**ALAMEDA COUNTY CDA  
PLANNING DEPARTMENT**

**STAFF REPORT**

**APPLICATION: Vesting Tentative Tract Map & Site Development Review, PLN2017-00067**

**PROPOSAL:** Construction of 20 three-story townhomes and corresponding subdivision into four (4) building lots and three (3) common lots by Vesting Tentative Tract Map 8408, with a gross density of 17.9 units per acre. The townhomes would be 35 feet in height, with two-car garages in each, plus 15 off-street guest parking spaces (including one handicapped-accessible space) and up to six on-street guest parking spaces, and would result in a total lot coverage of 42 percent.

**PLN2017-00067**  
**BAKER ROAD TENTATIVE MAP**

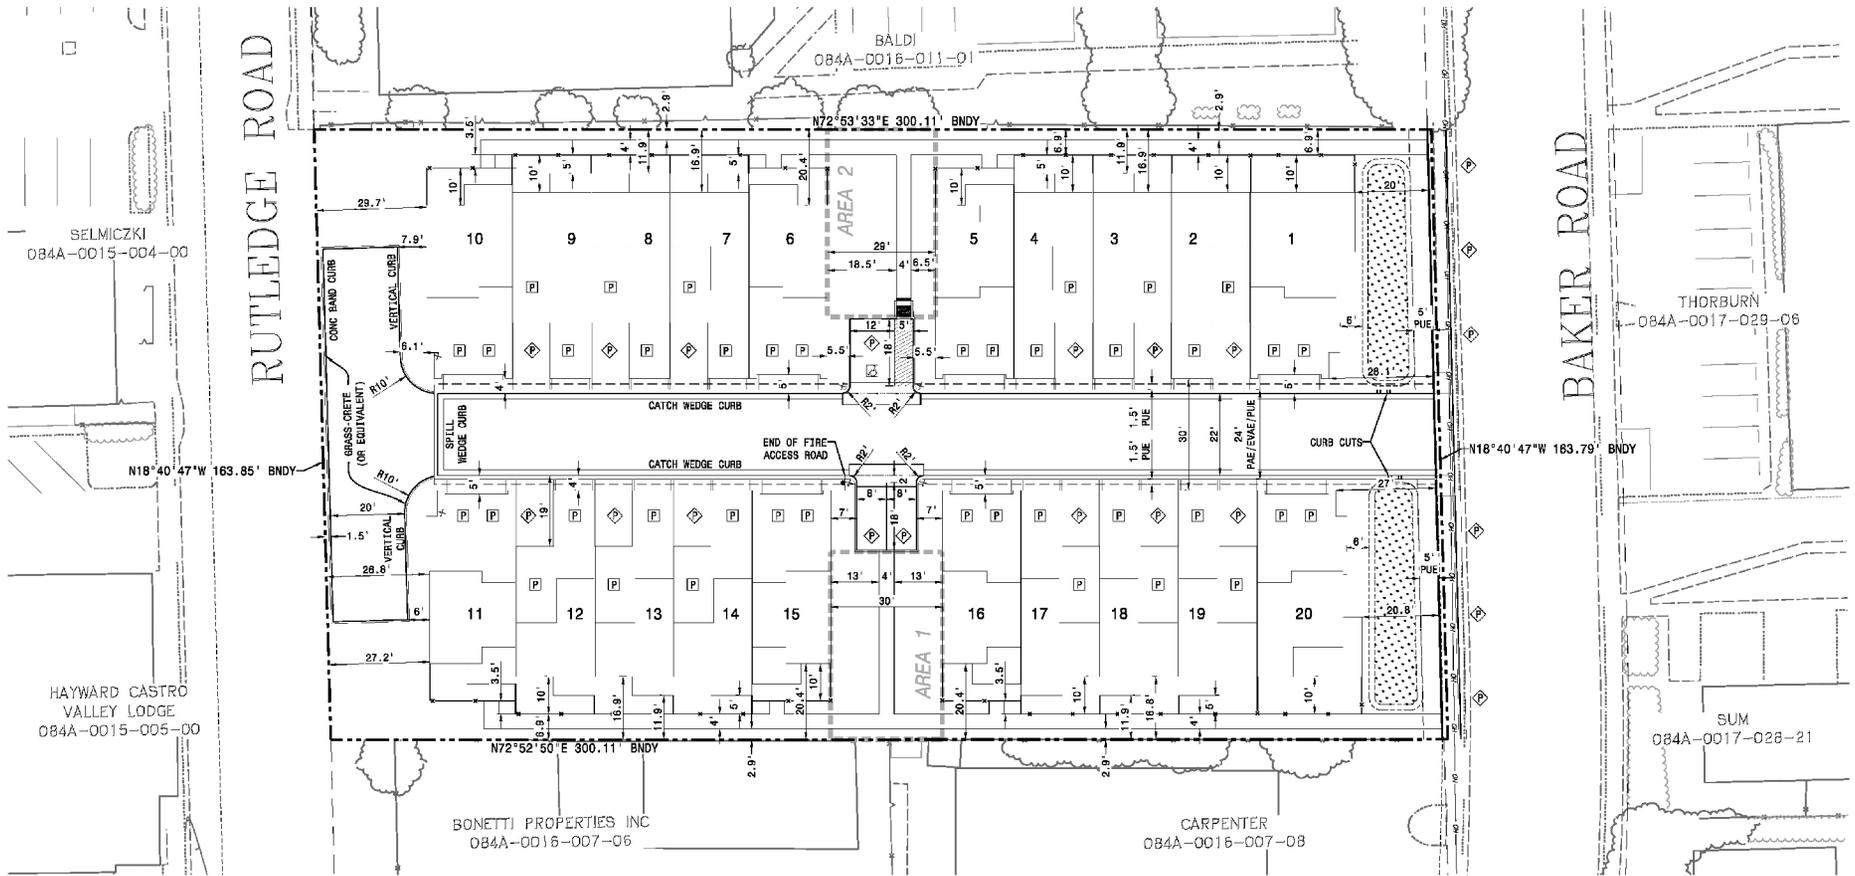
4. The preliminary improvement plans do not identify storm drainage system. Please ensure that the project proponent provides design details for the storm drainage and stormwater treatment systems at the site.

7. The proposed driveway entrance shall conform to the latest Caltrans Revised Standard Plan, RSP A87A.
8. On Sheet 1 of the civil plans, note 6 should be corrected to indicate that the flood hazard area is on the northwesterly portion of the site, not the northeastern corner. The floodwaters would be coming from Chabot Creek, to the west.

9. Sheet 2 of the civil plans describes an undergrounding of the utility lines in the roadway right of way, but it is unclear how this will be transitioned to the adjacent frontages.
